Access Compliance Report

Public Rights-of-Way

Intersection ID: 28929	Main Street: WADE_ARDREY_RD	Cross Street: CAMPBELL_HALL_CT	Location: SW
ADA ID: 17B73094729C	Ramp Type: PerpDiag	Initial Pass/Fail: Fail	Overall Compliance: No
Severity Score: 58.75			
Codes/Mitigation Info/Possible Solution		Field Measurements/Component Compliance

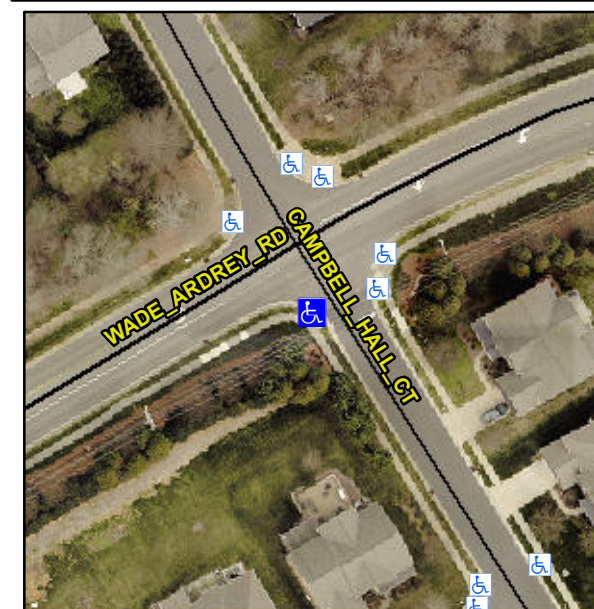
Not Found, R304.5.1, R304.2.2, R304.5.3

Compliance	Description	Data	Compliance	Description	Data
N/A	Ramp Length (in)	45.5	No	Ramp Slope (%)	12.2
No	Ramp Width (in)	46.0	No	Ramp XSlope (%)	9.6
N/A	Flare Type LT	N/A	N/A	Flare Type RT	N/A
N/A	Flare Slope LT (%)	N/A	N/A	Flare Slope RT (%)	N/A
N/A	Flare Traversable LT?	N/A	N/A	Flare Traversable RT?	N/A
N/A	Landing Length (in)	N/A	N/A	DWS Provided?	N/A
N/A	Landing Width (in)	N/A	N/A	DWS Contrast?	N/A
N/A	Landing Slope (%)	N/A	N/A	DWS Length (in)	N/A
N/A	Landing X Slope (%)	N/A	N/A	DWS Full Width?	N/A
N/A	Landing Curb? (Y/N)	N/A	N/A	DWS Offset (in)	N/A
N/A	Shared Landing?	N/A			
N/A	Gutter Ponding?	N/A	N/A	Gutter Slope (%)	N/A
N/A	Gutter Lip Ht (in)	N/A	N/A	Gutter X Slope (%)	N/A
N/A	Painted X Walk1?	No	N/A	Painted X Walk2?	No
	X Walk 1 Direction	To SE		X Walk 2 Direction	To NW
N/A	X Walk 1 Width (in)	N/A	N/A	X Walk 2 Width (in)	N/A
	X Walk 1 Slope (%)	7.4		X Walk 2 Slope (%)	2.3
	X Walk 1 X Slope (%)	2.8		X Walk 2 X Slope (%)	8.8

Remove & Replace Curb Ramp With Two New Directional Ramps or Equivalent.
